Contract #: 04-0120F4Cty: SF/ALA Rte: 80 PM: 13.2/13.9File #: 69.25B**QUALITY ASSURANCE -- NON-CONFORMANCE REPORT****Location:** Changxing Island, Shanghai, P.R. China**Report No:** NCR-000373**Prime Contractor:** American Bridge/Fluor Enterprises, a JV**Date:** 06-Aug-2009**Submitting Contractor:** Zhenhua Port Machinery Company, Ltd (ZPMC), Changxing Island**NCR #:** ZPMC-0347**Type of problem:**

Reference Description: Undercut welds were accepted by QC at Crossbeam 2**Description of Non-Conformance:**

Job Name: SAS Superstructure

Subject: NCR No. ZPMC-0347

QUALITY ASSURANCE -- NON-CONFORMANCE REPORT

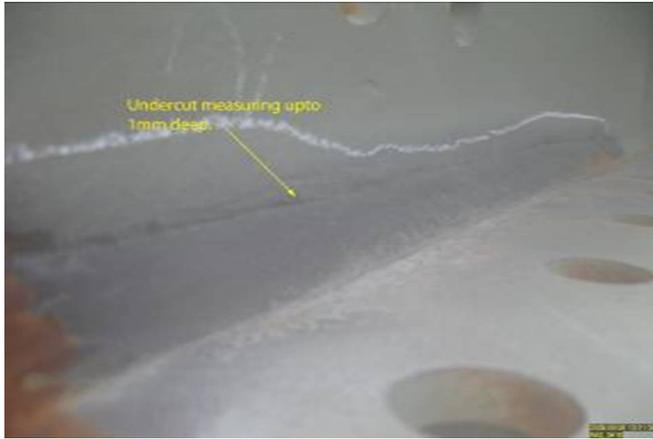
This Quality Assurance (QA) Inspector perform VT and MT inspection on holdback welds at the CB204A-004, 006, 010, 012, 016, 018, 023 and 024. Rejectable undercuts were found measuring up to a maximum of 1.75 mm deep in multiple (SPCM) Hold back areas. These welds are listed below. These welds were previously approved and accepted by ZPMC QC.

SP220A-1 To BP215A-1 (SP to BP Corner Joint With Fillet)
 SP220A-2 To BP215A-2 (SP to BP Corner Joint With Fillet)
 BP212A-1 To FB212A-1 (FB to BP Fillet weld)
 BP212A-2 To FB212A-2 (FB to BP Fillet weld)
 BP216A-1 To SP 217A-1 (SP to BP Corner Joint With Fillet)
 BP216A-2 To SP 218A-2 (SP to BP Corner Joint With Fillet)

AWS D1.5-2002 section 6.26.1.5: In Primary members, undercut shall be no more than 0.25 mm (0.01 in.) deep when the weld is transverse to tensile stress under any design loading condition. Undercut shall be no more than 1 mm (1/32) deep for all other cases.

Submit repair procedure to engineer for approval.
